Section 75W Modification Application Environmental Assessment Report

Block 6 + 7, Central Park

Modification to approved Project Application (MP 11_0091)

December 2013 ■ 11316

Figure 6 – Existing and proposed parapet height of 40-42 Kensington Street

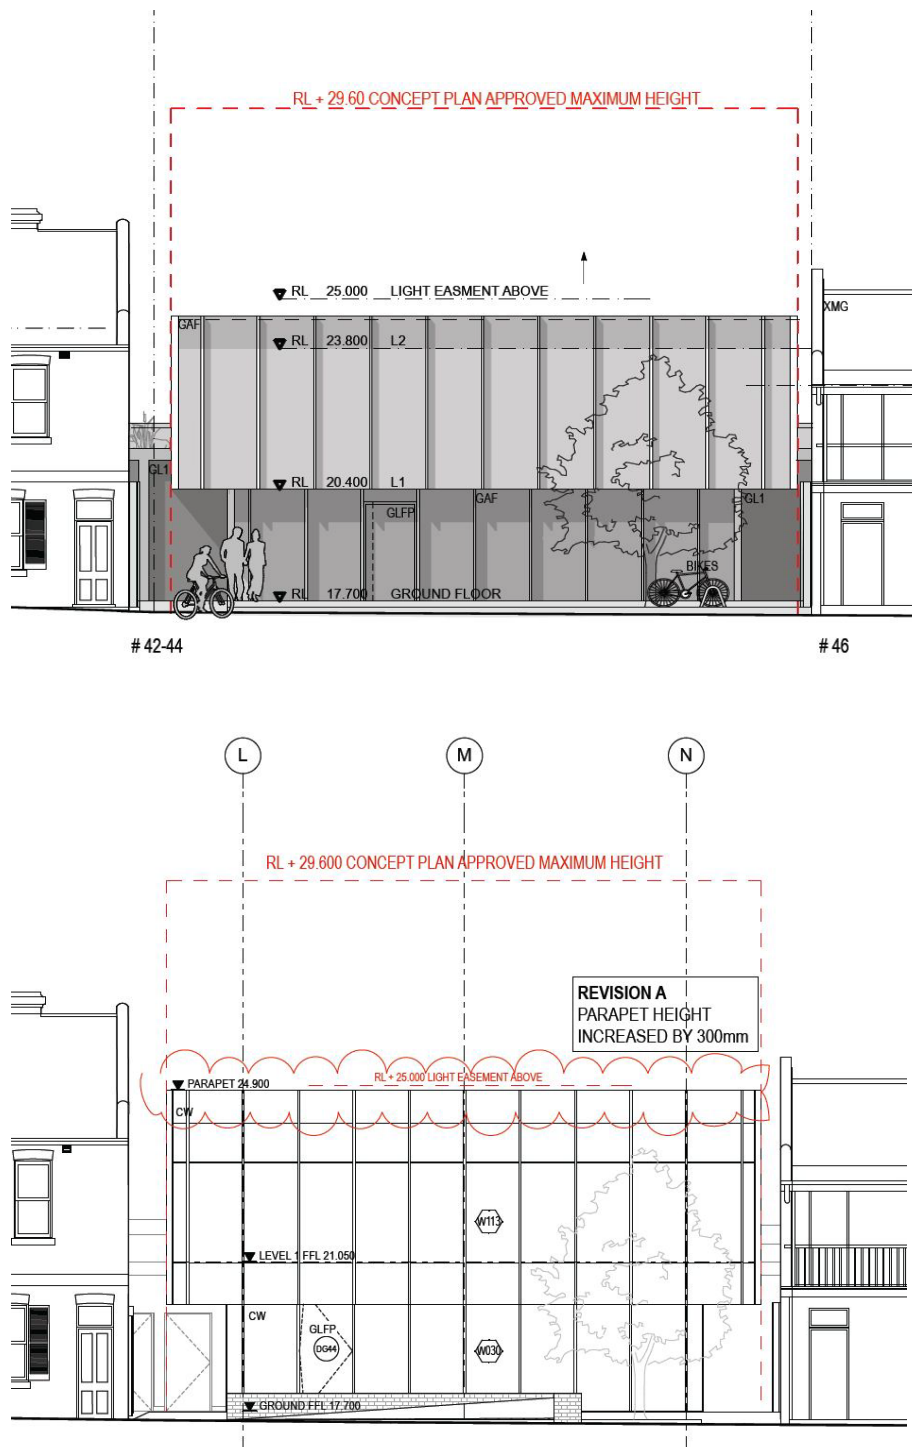
A minor increase to the parapet of Nos. 40-42 is proposed. The increase consistent of a 300mm increase, and will remain below the established Concept Plan envelop and easement for light above, which commences at an RL of 25.00. The height of the proposed parapet will be to RL 24.90. **Figure 6** below, illustrates the minor increase by comparing the existing approved building and parapet with an excerpt of the proposed building located at 4-42 Kensington Street.

The proposed amendments are consistent with approved Project Application. The minor variations to the approved building envelope arise from a modification to the parapet height of No. 40-42 (increasing by 300mm to RL 24.9).

Figure 7 – Rear elevation of No 2-12 Kensington Street

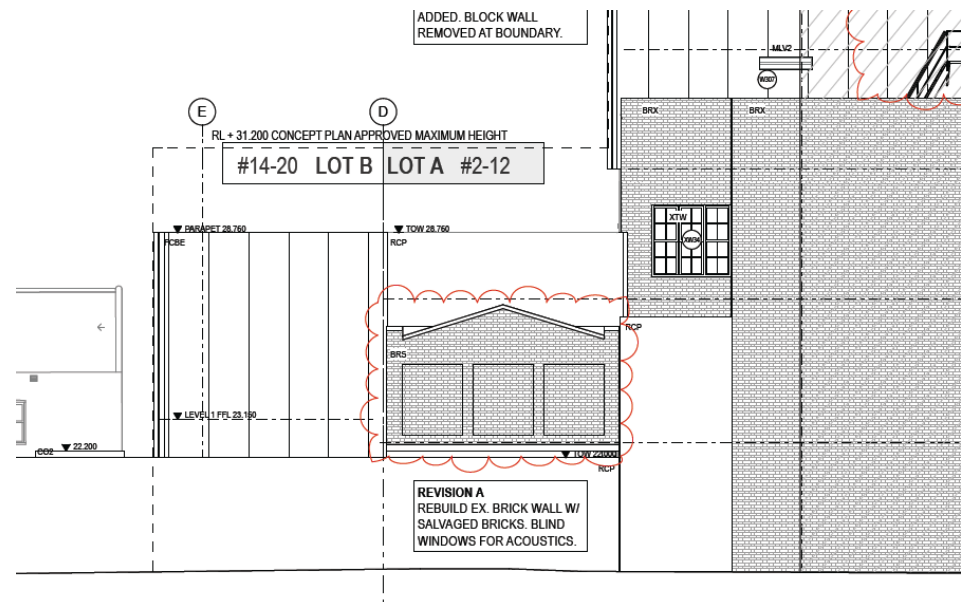
As part of the amendments, further on-site and structural investigations have been carried out. As a result it is proposed to demolish and rebuild the existing brick wall located to the rear of No. 12, as well as the brick wall located between Nos. 10-12 that were previous proposed to be retained. As annotated on the plans at **Appendix A**. The walls are proposed to be rebuilt in the same location and design reflecting the existing walls with salvaged existing bricks on site (see **Figure 7**).
